Change Notice

IS Series

Changes for OLED Module & Driver IC in SmartSwitch Rocker

SmartSwitch Rocker Changes
for OLED Module & Driver IC

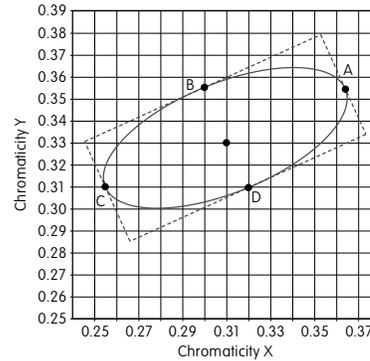
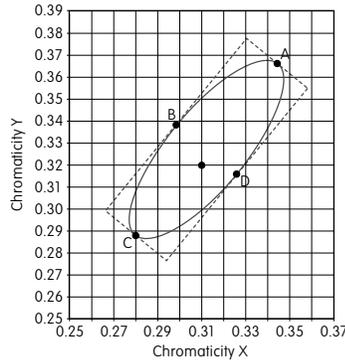
The IS Series Rocker will have a different OLED module and driver IC. This revision will effect standard and custom rockers, including any assembled in the IS Development or Engineering Kits. Standard part numbers are shown below. Tables depict the various specification differences before and after the change to the new module and IC driver.

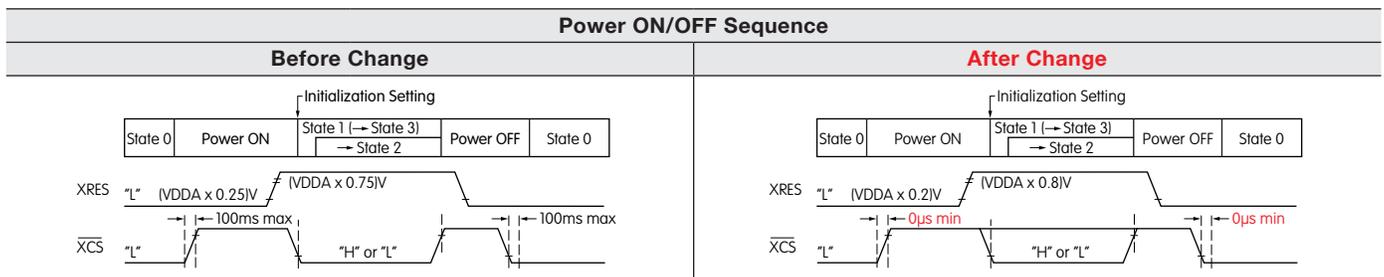
Timing Specifications – AC Characteristics							
(Temperature at -20°C ~ +70°C), VDDA = 2.8V, VAH = 16V		Before Change			After Change		
Items	Symbols	Minimum	Typical	Maximum	Minimum	Typical	Maximum
Clock Cycle Time	t _{cycle}	100ns	—	—	100ns	—	—
A0 Setup Time	t _{SWDS}	65ns	—	—	65ns	—	—
A0 Hold Time	t _{SWDH}	35ns	—	—	35ns	—	—
XCS Setup Time	t _{CWS}	65ns	—	—	65ns	—	—
XCS Hold Time	t _{CWH}	95ns	—	—	35ns	—	—
High Level XCS Pulse Width	t _{CSBH}	* 10ns	—	—	30ns	—	—
Write Data Setup Time	t _{WDTS}	10ns	—	—	10	—	—
Write Data Hold Time	t _{WDTH}	20ns	—	—	30ns	—	—
SCL Low Time	t _{SCLL}	45ns	—	—	45	—	—
SCL High Time	t _{SCLH}	45ns	—	—	45	—	—
SCL Rise Time	t _r	—	—	15ns	—	—	15ns
SCL Fall Time	t _f	—	—	15ns	—	—	15ns

* Requires more than 100ns after resetting software
